COUNCIL ASSESSMENT BRIEFING REPORT TO PANEL

SYDNEY EASTERN CITY PLANNING PANEL

PANEL REFERENCE & DA NUMBER	PPSSEC-239 – DA-455/2022
PROPOSAL	Demolition of Bronte Surf Club building and construction of a new Bronte Surf Life Saving Club building and associated community facility upgrades including pathway access upgrades
ADDRESS	Lot 7102 DP 1058385 Bronte Road, Bronte
APPLICANT	Waverley Council (Ms. S Cassidy)
OWNER	Crown Lands (Managed by Waverley Council)
DA LODGEMENT DATE	18 October 2022
APPLICATION TYPE	Development Application
REGIONALLY SIGNIFICANT CRITERIA	Schedule 6, Clause 3 of <i>State Environmental Planning Policy (Planning Systems)</i> 2021 – Council Related Development over \$5 million and Clause 5 Community Facility over \$5 million
CIV	\$13,541,725.00 (excluding GST)
CLAUSE 4.6 REQUESTS	N/A
LIST OF ALL RELEVANT PLANNING CONTROLS (S4.15(1)(A) OF EP&A ACT)	 Coastal Management Act 2016 State Environmental Planning Policy (Biodiversity and Conservation) 2021 State Environmental Planning Policy (Planning Systems) 2021 State Environmental Planning Policy (Resilience and Hazards) 2021 Waverley Local Environmental Plan 2012 (WLEP); Waverley Development Control Plan 2012 (WDC

Figure 1: Indicative temporary facilities layout plan prepared by Warren and Mahoney Architects

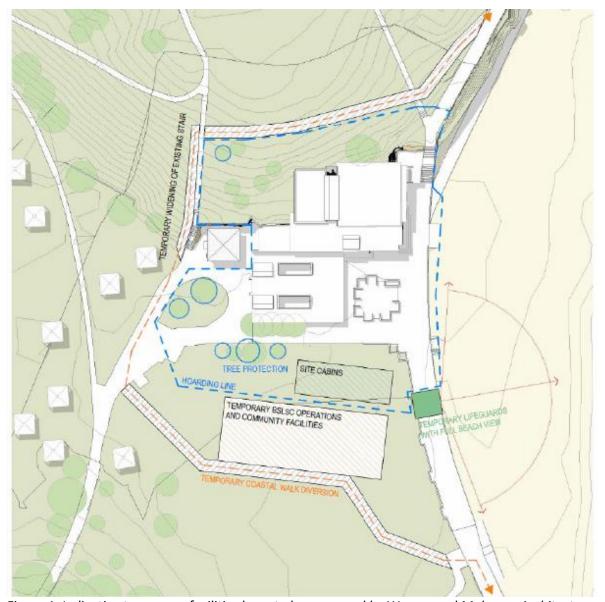
In order to commence demolition of the existing SLSC building, temporary facilities will be constructed adjacent to the southern portion of the site in Bronte Park, to allow the lifeguard and SLSC functions

In order to undertake these works, the site will need to be enclosed with perimeter fencing and all materials will be delivered (by escort) to the site from the Bronte Road accessway. The applicant has provided the figure below to show the indicative temporary facilities layout.

Proposed Condition 41 (to be included under 'Before Building Work Commences'):

Prior to the commencement of works, a Construction Management Plan is to be prepared and submitted to Council for approval. The Construction Management Plan should provide building and operational details of the temporary facilities intended to be used for surf lifesaving operations during the construction of the Bronte Surf Life Saving Club.

The inclusion of this recommended condition is supported.
